HISTORIC LANDMARK COMMISSION
STAFF REPORT

Portmann Rear Addition
PLNHLC2014-00147
1371 Filmore Street
May 1, 2014

A request by David Clayton, architect, to build a rear addition to the existing residence at the above referenced address.

ELEVATIONS

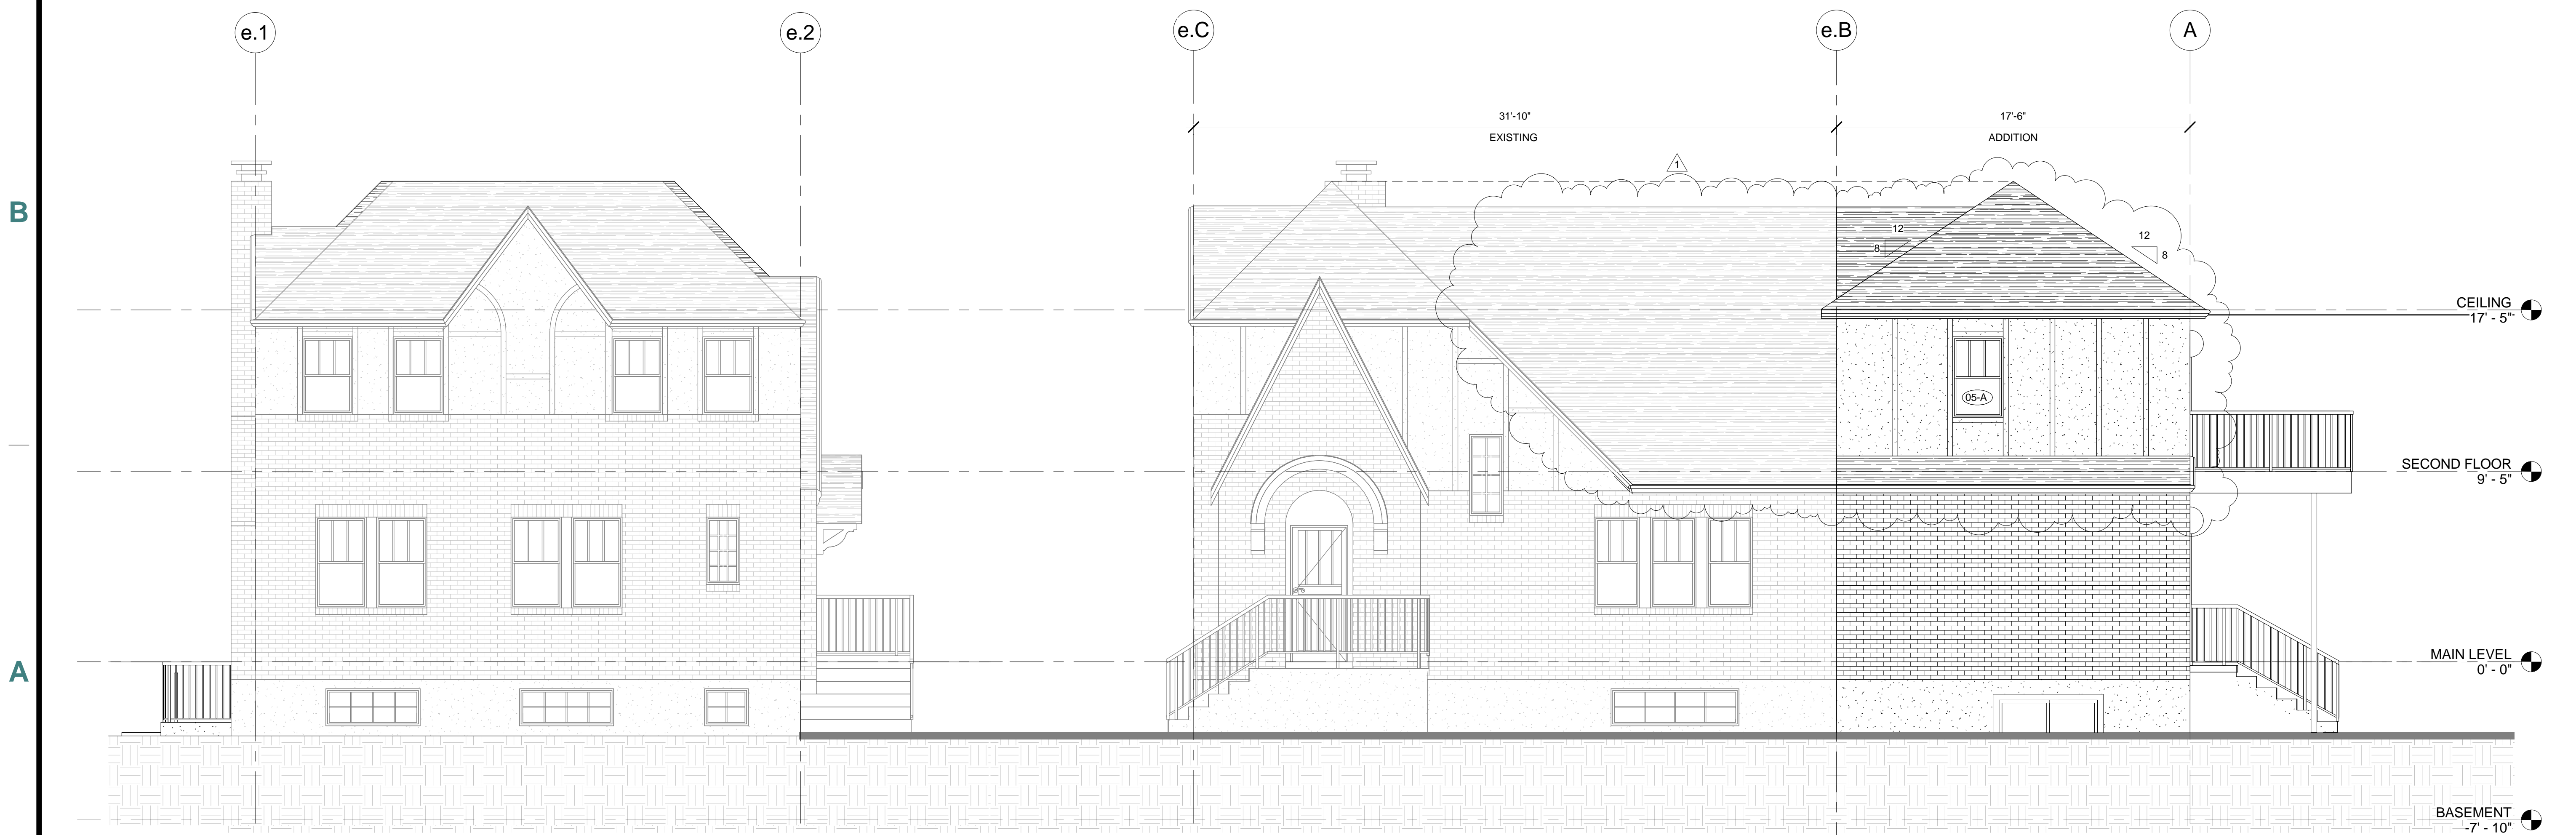
Analysis: The home is located midblock and the rear elevation is not readily visible from the public way. The proposed addition will eliminate the existing rear building façade. None of the current features of the rear façade appear to be historically important architectural features. The proposed addition is designed to be compatible with the size and scale of the main building. The materials proposed for the new addition are compatible with the historic materials of the primary building. The style of the windows and doors are appropriate. The roofline of the addition will replicate the roofline of the front of the house. The walls of the addition will be stepped-in and the color of the brick of the addition will be slightly differentiated from the existing brick distinguishing the old from the new.

Analysis: The proposed step-in of the wall and brick color differentiation will contribute to the recognition of this proposed addition as one of its own time.

Analysis: The addition as proposed, for the most part, preserves the original structure in both form and physical integrity, and if said addition were built and subsequently removed, the original structure would be unimpaired. The walls of the addition will be stepped-in and the color of the brick of the addition will be different from the existing brick to distinguish the old from the new.
